WATER PERMIT NO. 8236-3

**RECOMMENDATION OF CHIEF ENGINEER FOR WATER PERMIT
APPLICATION NO. 8236-3, Arnie Beisch**

**REPORT TO THE CHIEF ENGINEER
ON
WATER PERMIT APPLICATION NO. 8236-3
ARNIE BEISCH
SEPTEMBER 14, 2016**

Figure 2. Schematic of test hole logs submitted with Water Permit Application No. 8236-3

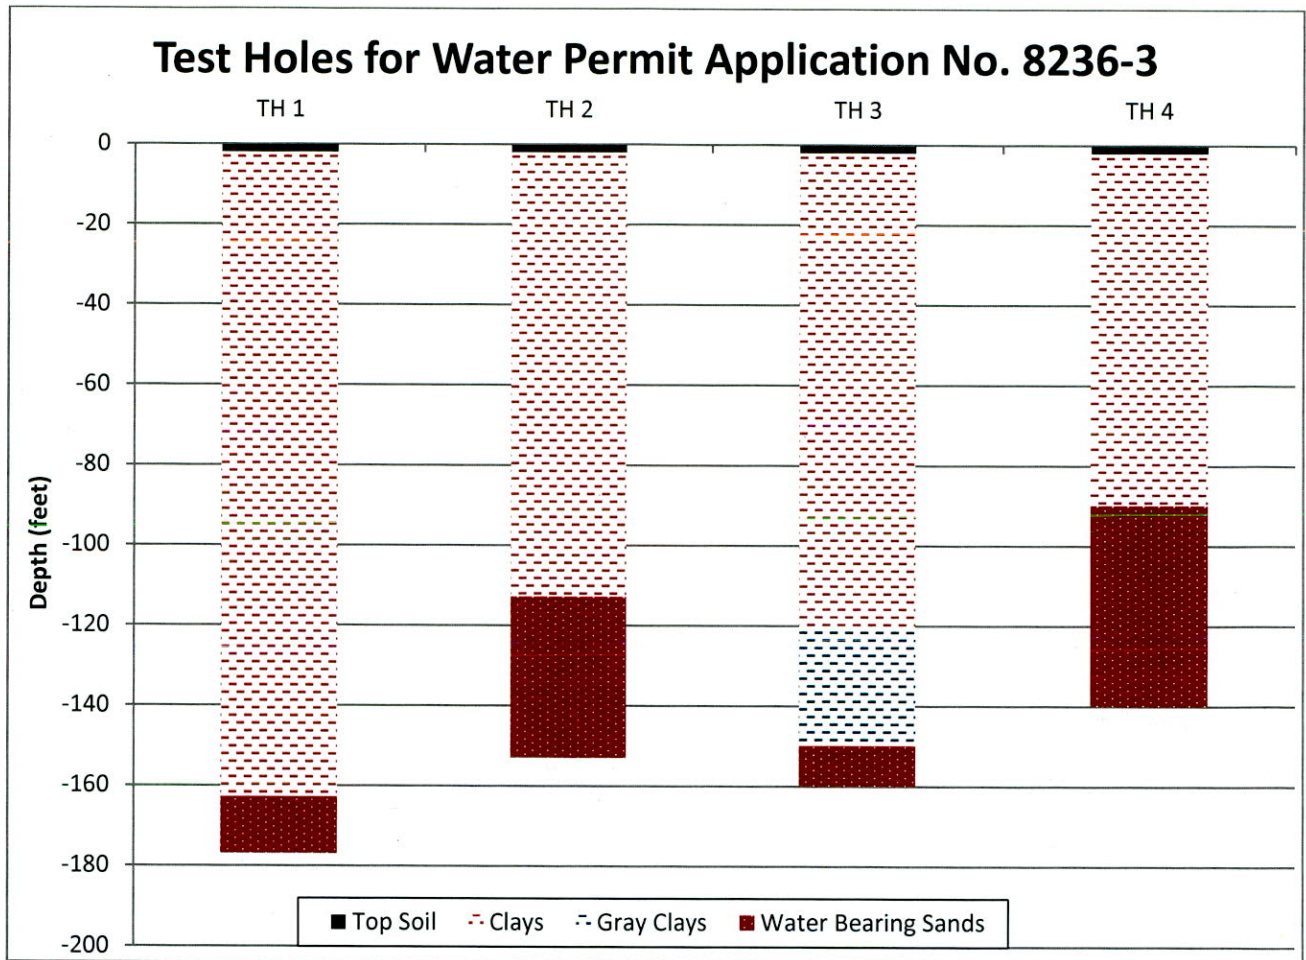
The logs for the test holes indicate the aquifer materials vary considerably in depth and thickness within short distances. The aquifer materials encountered in the test holes occur between the approximate altitudes of 1,707-1,763 feet above mean sea level elevation (fmsl) and could be classified an intermediate aquifer. Hedges and others, (1982) mapped an intermediate aquifer, the **Prairie Coteau**, covering large portions of Marshall, Day, Roberts, Grant, Codington and Clark Counties, including the project area proposed by this application. Subsequently, more detailed mapping of this area, done for the *Geology and Hydrology of Day County South Dakota*, did not identify an aquifer in this vicinity at the altitude of the sand and gravel reported on the test holes drilled for Water Permit Application No. 8236-3 (Leap,1988). The **Prairie Coteau** aquifer was mapped by Hansen (1990) and Hansen (1994) in nearby north-central Codington County and north-western Grant County, and akin to Hedges and others (1982), the aquifer was represented as a single, contiguous outwash deposit. The **Prairie Coteau** aquifer in Codington and Grant Counties was portrayed as being approximately between the elevations of 1,700-1,750 fmsl (Hansen, 1990). As part of *Water Resources of the Lake Traverse Reservation, South and North Dakota, and Roberts County, South Dakota*, a study area including the well sites proposed by this application was examined (Thompson, 2001). Thompson states:

Figure 1. Map showing the areal extent of the Surface Outwash in the *Ground-Water Supply for the City of Waubay, South Dakota* study area (modified from Beffort and Hedges, 1967).

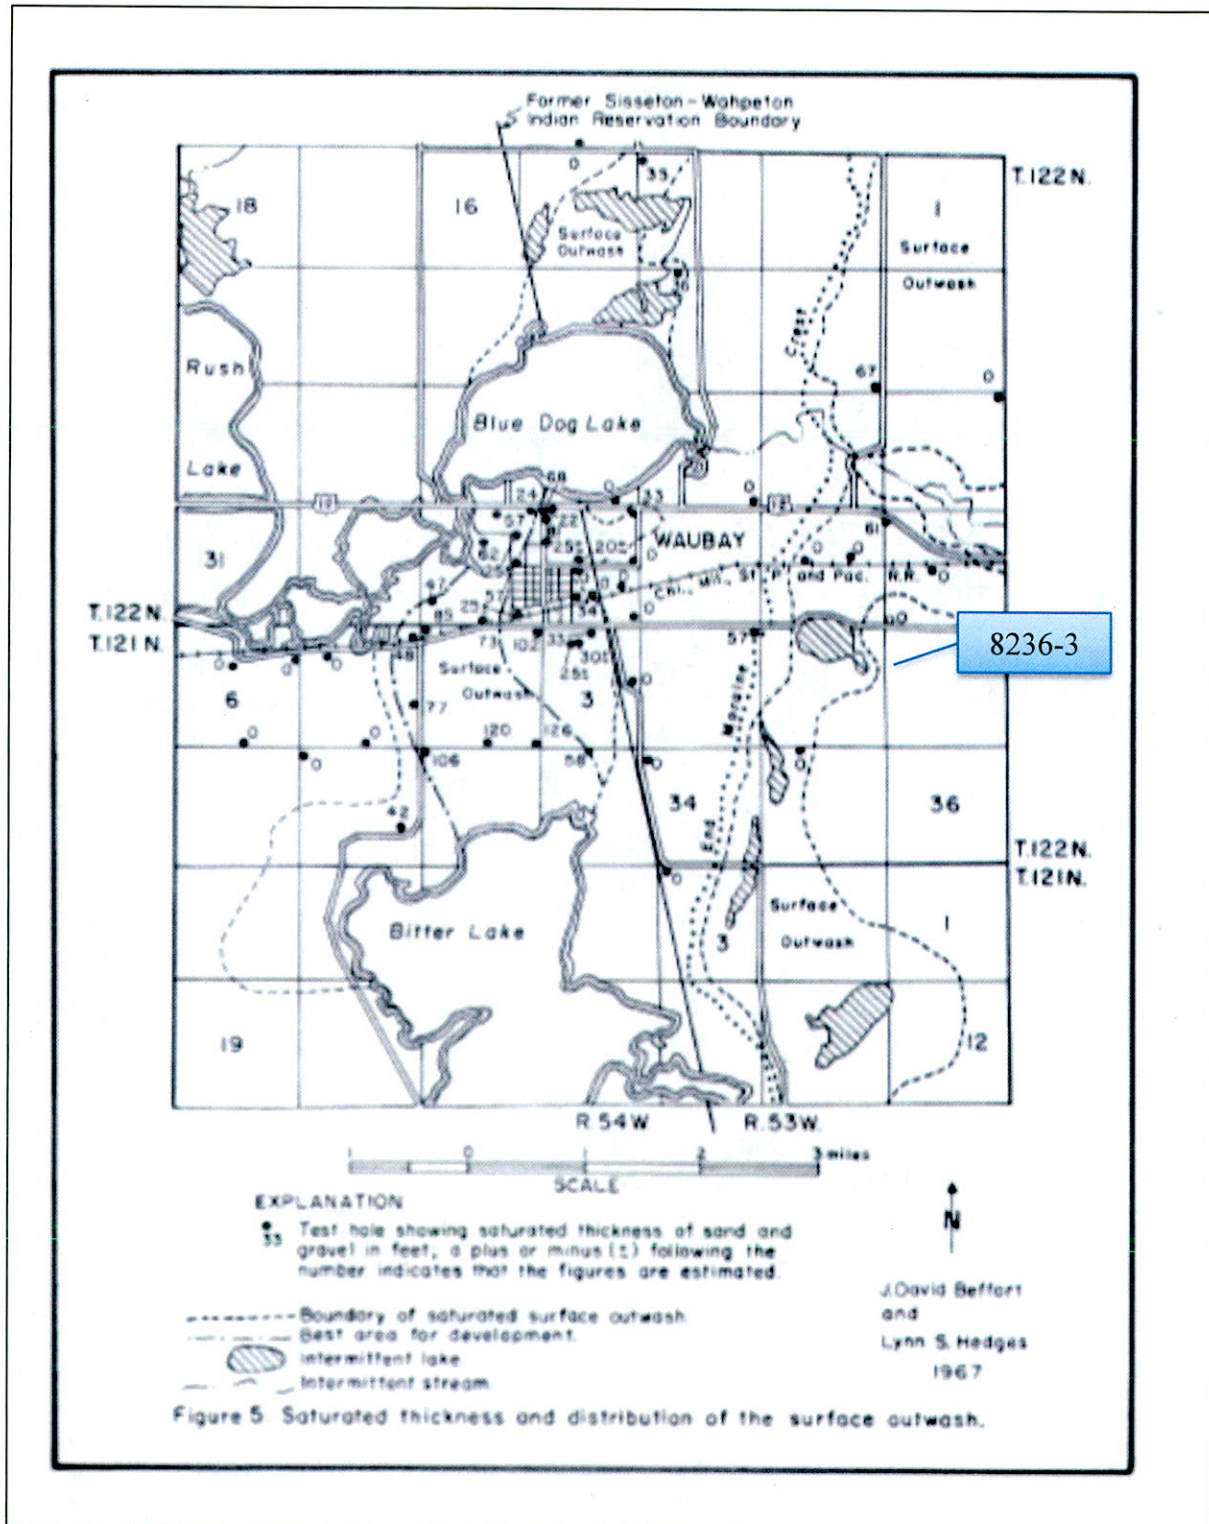
In *Ground-Water Supply for the City of Waubay, South Dakota*, by Beffort and Hedges (1967), a surface outwash was identified near the well sites proposed by this application (see Figure 1). This glacial outwash deposit appears to be a member of what was later named the Eastern Lakes Subsystem (Leap, 1972 and Leap, 1988). The Eastern Lakes Subsystem is a “complex system of several aquifers of varying thicknesses and elevations” (Leap, 1972). Hedges and others (1982) subsequently identified the surficial deposits in this area as part of the Coteau Lakes aquifer [system] which underlies approximately 58,200 acres of Day County, an estimated 32,000 acres of Marshall County, and parts of Roberts County. Leap (1988) identified the thickest part of his Eastern Lakes Subsystem as the Waubay aquifer and mapped a separate surficial outwash deposit approximately two miles east of the Waubay aquifer (see Figure 2). The surface outwash in this area is likely hydraulically connected to Blue Dog Lake and possibly Bitter Lake. Leap (1988) suggests groundwater flow occurs between Blue Dog Lake and Bitter Lake through the Waubay aquifer.

The DENR-Water Rights Program monitors eight observation wells completed into the outwash deposit this application proposes to appropriate water from (Water Rights, 2017a). Hydrographs for the observation wells are shown in Figures 3-10.

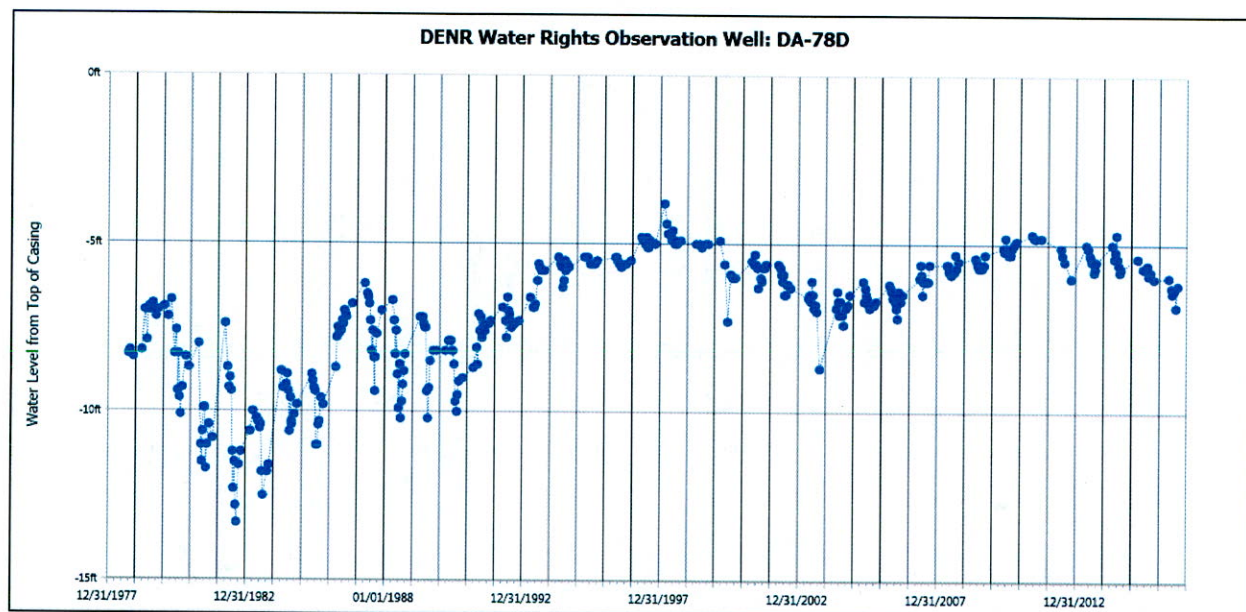
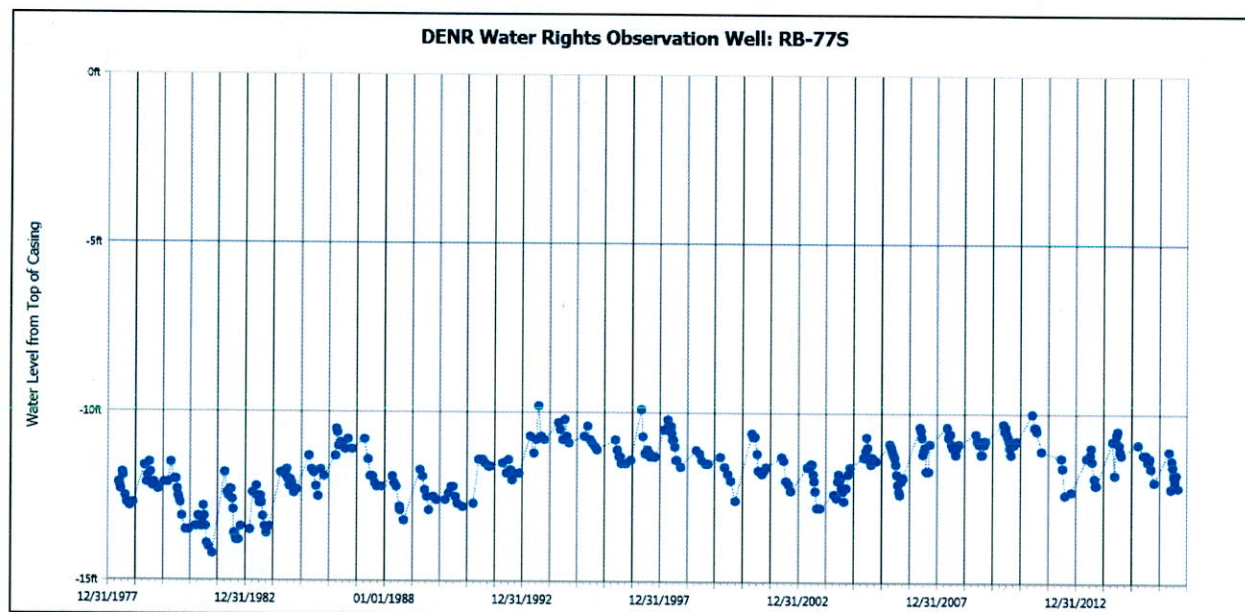
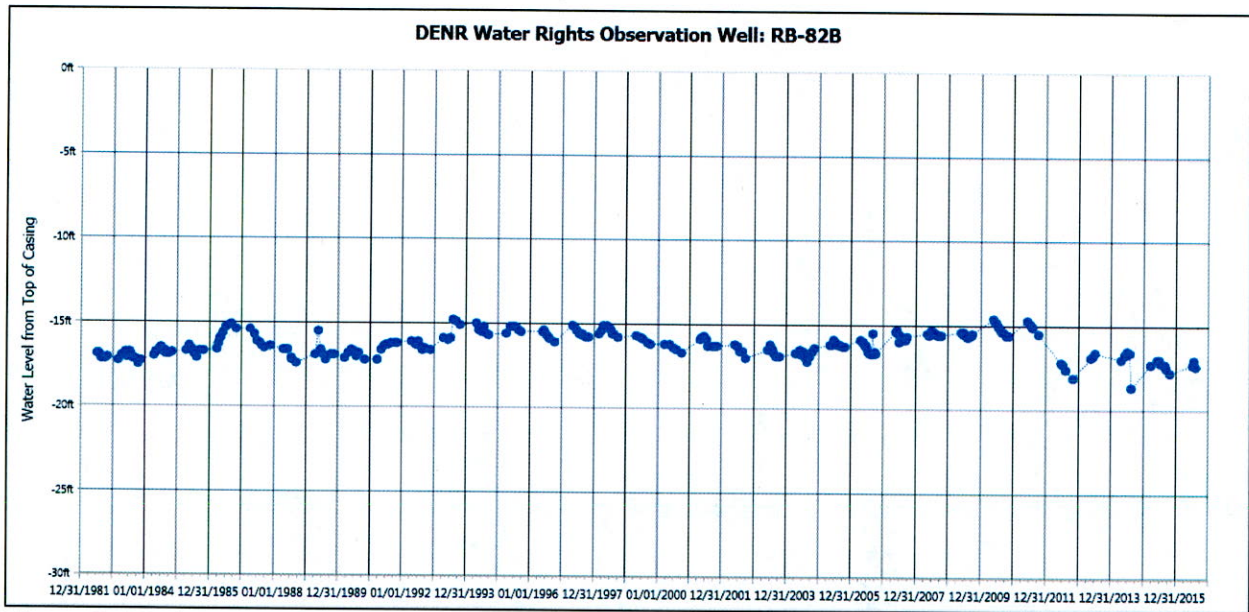
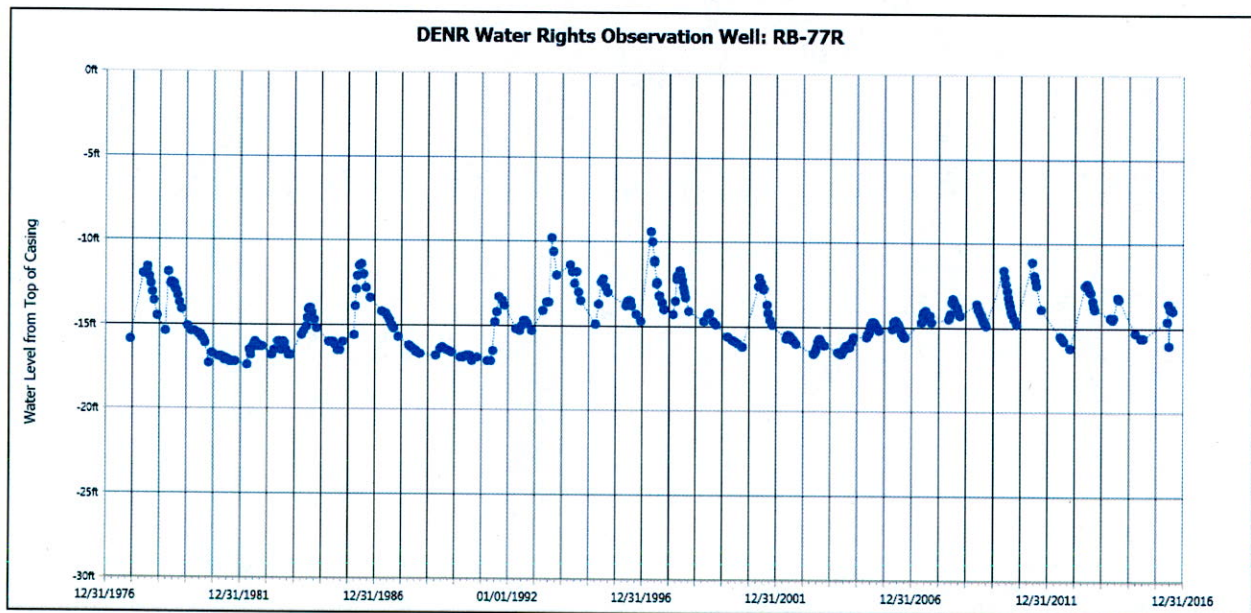
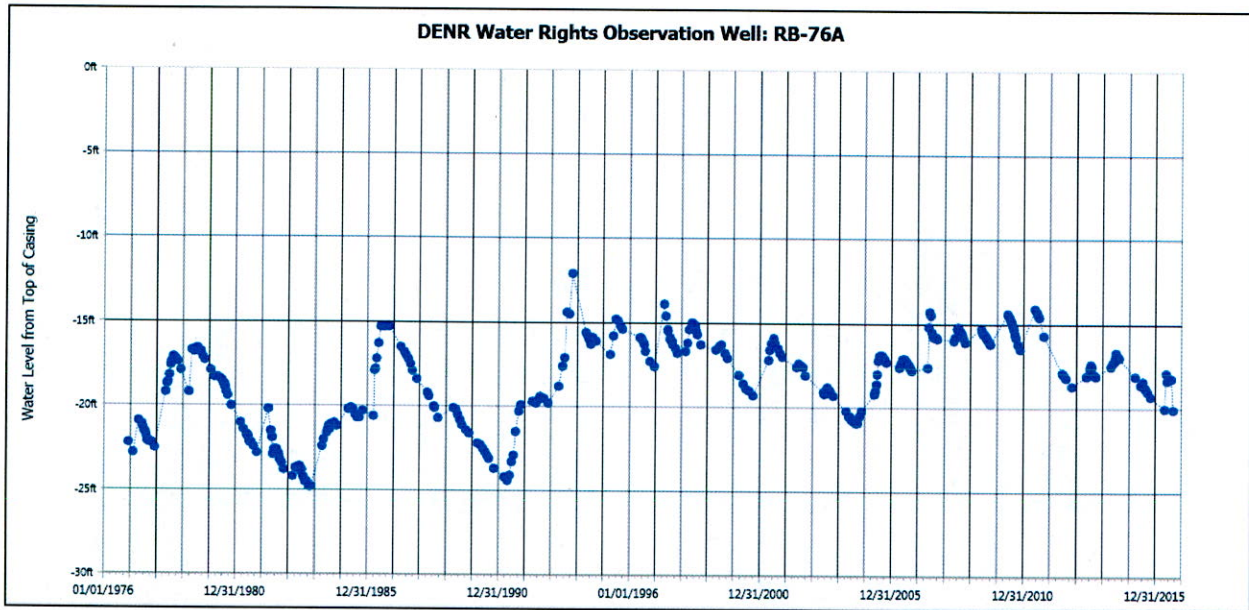
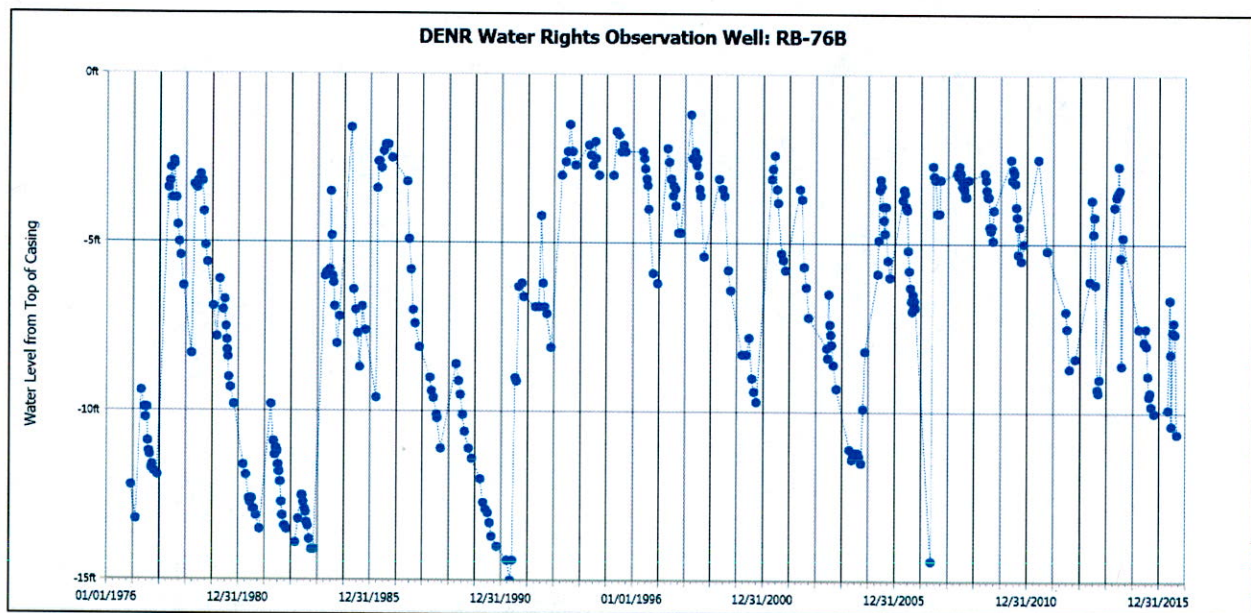
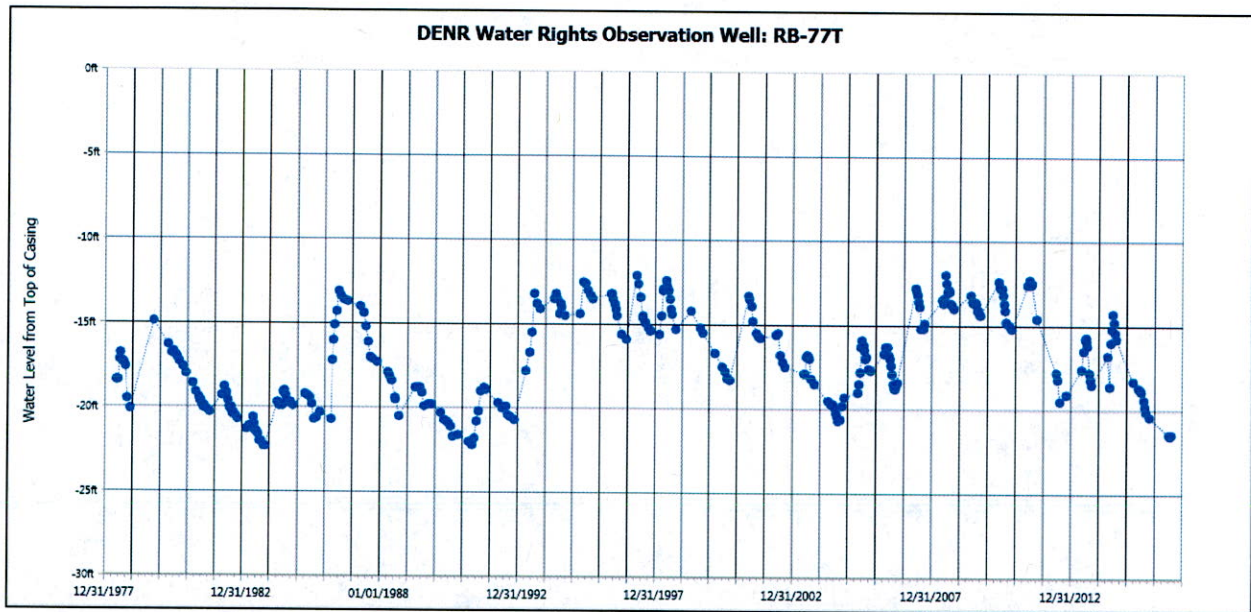
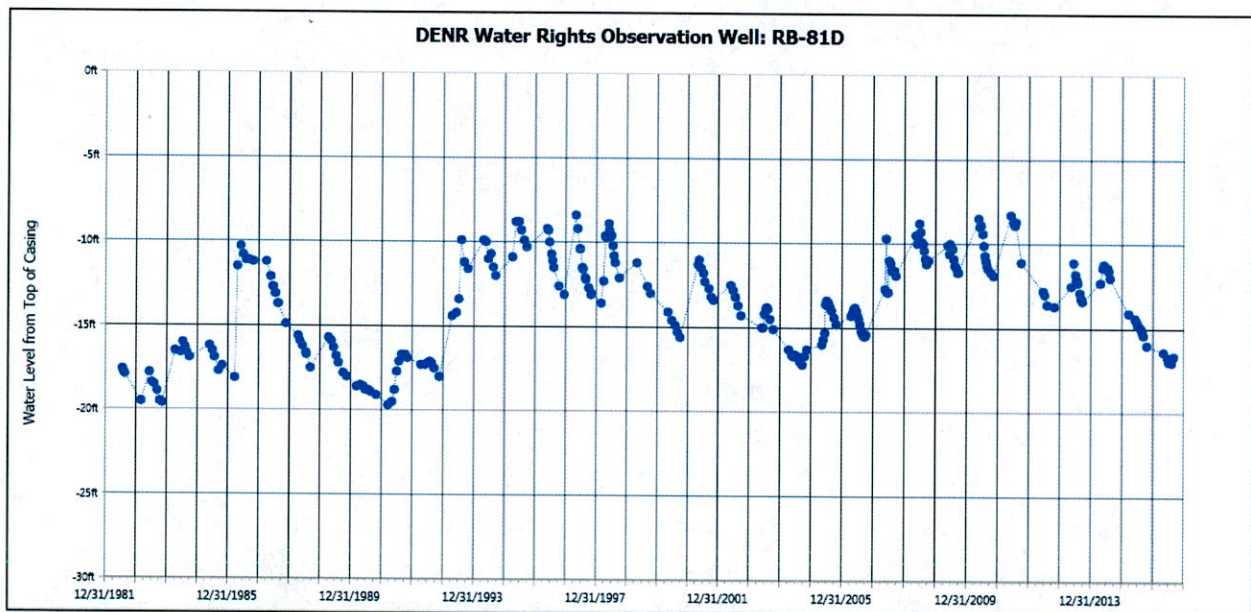
The hydrographs show that the water level of the aquifer responds to climatic conditions with rising water levels during periods when recharge exceeds withdrawals, and declining water levels during periods when withdrawals exceed recharge. Some of the hydrographs document a total amplitude of water level fluctuation in excess of 13 feet (see Figure 8) while in other portions of the aquifer the amplitude has been around four feet (see Figure 5). Although annual
